Subject: Oakley Generating Station Project (09-AFC-4)  
Response to CEC Staff Data Requests # 68-73

APPLICATION FOR CERTIFICATION  
Response to Data Requests 68–73

# *Oakley Generating Station*

**Responses to CEC Staff  
Data Requests 68 through 73**

**FIGURE DR68-1**  
**INORGANIC NITROGEN WET DEPOSITION**  
**FROM NITRATE AND AMMONIUM, 2008**  
 OAKLEY GENERATING STATION RESPONSE TO DATA REQUESTS  
 OAKLEY, CALIFORNIA

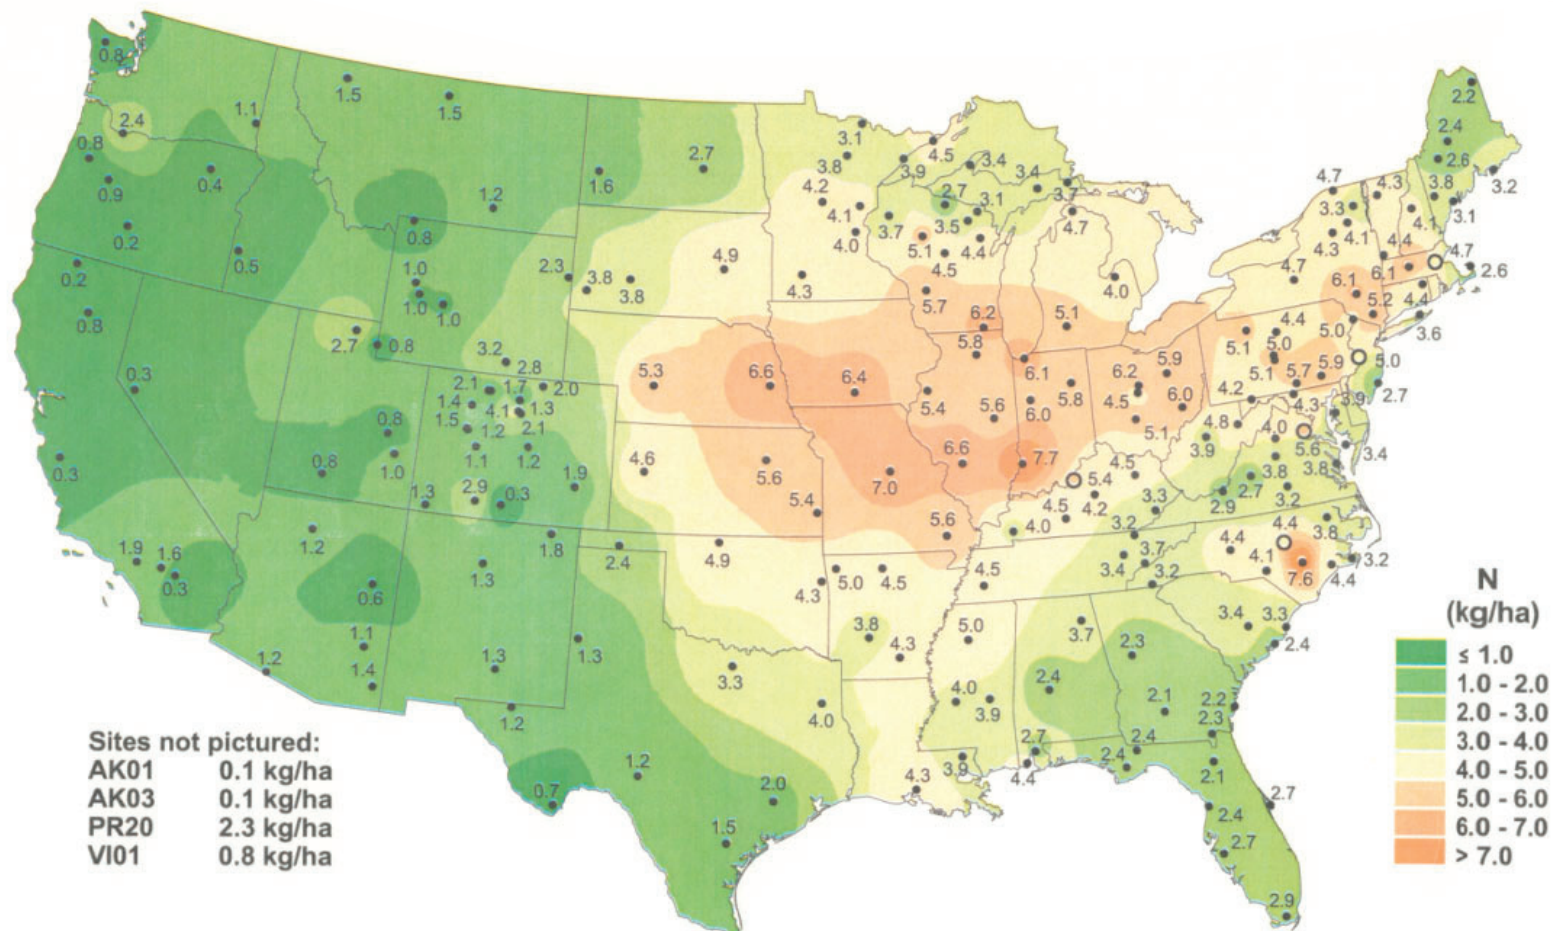
68. *Please quantify the existing baseline total nitrogen deposition rate in the vicinity of OGS in kg/ha/yr. The analysis should specify the amount of total nitrogen deposition in kg/ha/yr at the Antioch Dunes National Wildlife Refuge (ADNWR) for wet and dry nitrogen deposition. Please provide the complete citation for references used in determining this number.*

An isopleth data map from the NADP, National Trends Network at the University of Illinois Urbana-Champaign (NADP, 2010) (Figure DR68-1), shows average wet nitrogen deposition rates in the western and southeastern United States of generally less than 3.0 kg/ha/yr, with higher rates of 5.0 to 7.0 kg/ha/yr in the midwestern and northeastern states. Wet nitrogen deposition is used as a proxy for total nitrogen deposition because dry deposition rates are generally low and monitoring techniques for dry deposition are less reliable. Interpolating this data to the vicinity of the Antioch Dunes National Wildlife Refuge (ADNWR), the baseline value would be less than 1.0 kilogram per hectare per year (kg/ha/yr) in 2008.

**FIGURE DR69-1**  
**NITROGEN DEPOSITION IN ANTIOCH DUNES NWR**  
**(KG/HA/HR), BACKGROUND AND OGS PROJECT**  
 OAKLEY GENERATING STATION RESPONSE TO DATA REQUESTS  
 OAKLEY, CALIFORNIA

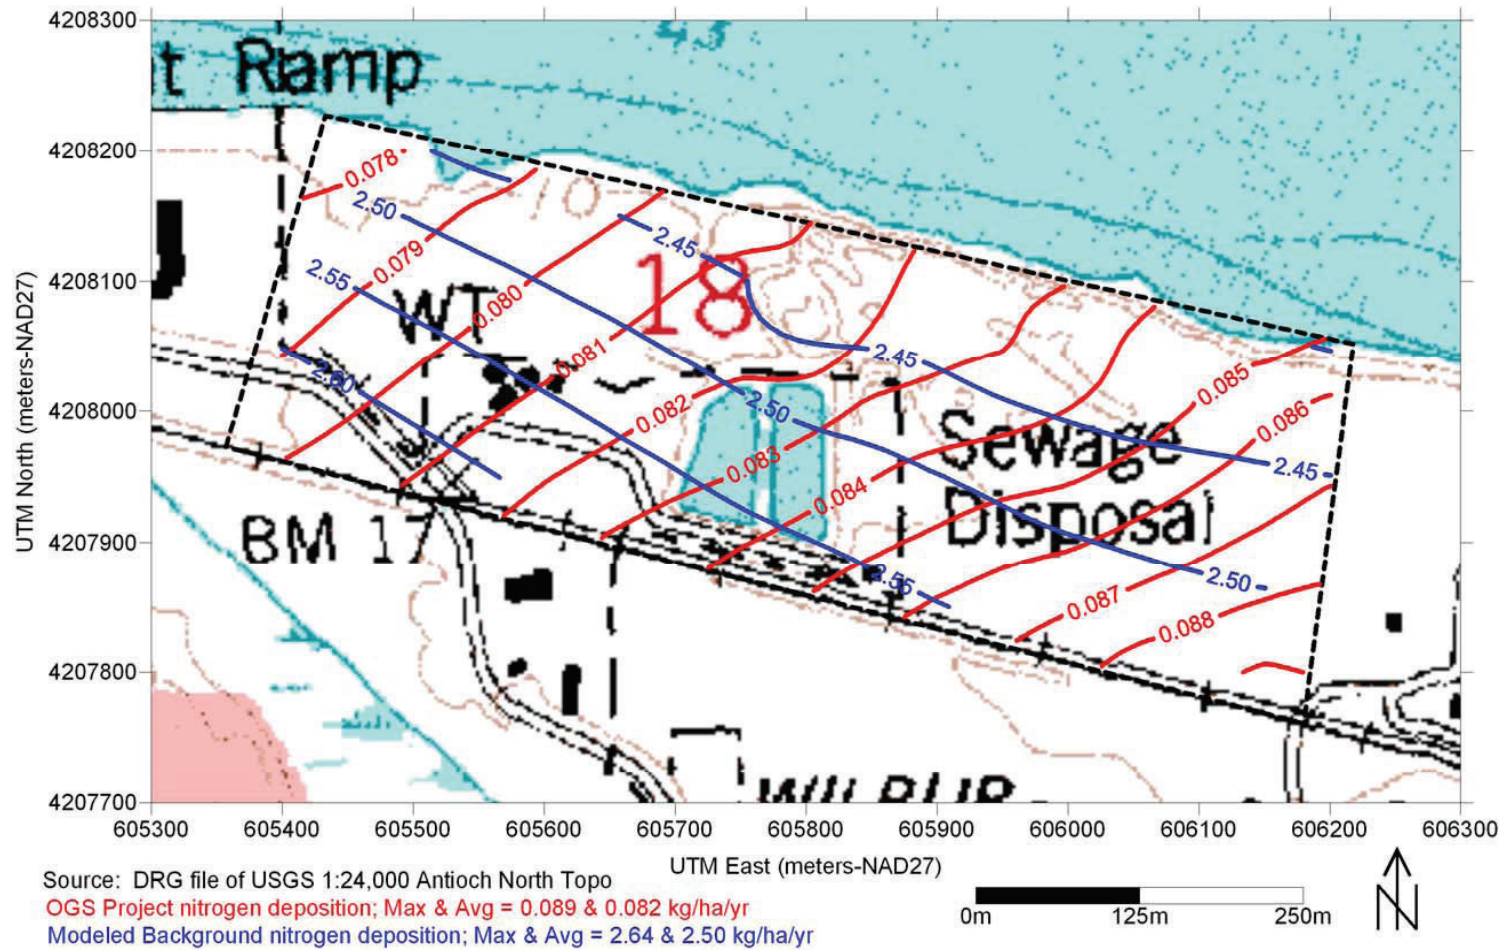
69. *Provide an isopleth graphic over USGS 7.5-minute maps (or equally detailed map) of the direct nitrogen deposition rates caused by the project that graphically depicts the results.*

**Response:** Figure DR69-1, is an isopleth map that has been placed over a USGS 7.5-minute map of the ADNWR with North American Datum coordinates (NAD-27). Two deposition

isopleths are displayed: (1) the red isopleths represent the OGS project by itself and (2) the blue isopleths are the modeled background nitrogen deposition isopleths without the OGS project. The modeled OGS project nitrogen deposition averages 0.083 kg/ha/yr, and the modeled background deposition rate averages 2.50 kg/ha/yr. Modeling methodologies used to develop the background and project level estimates are discussed below in the responses to Data Requests 70 and 71.
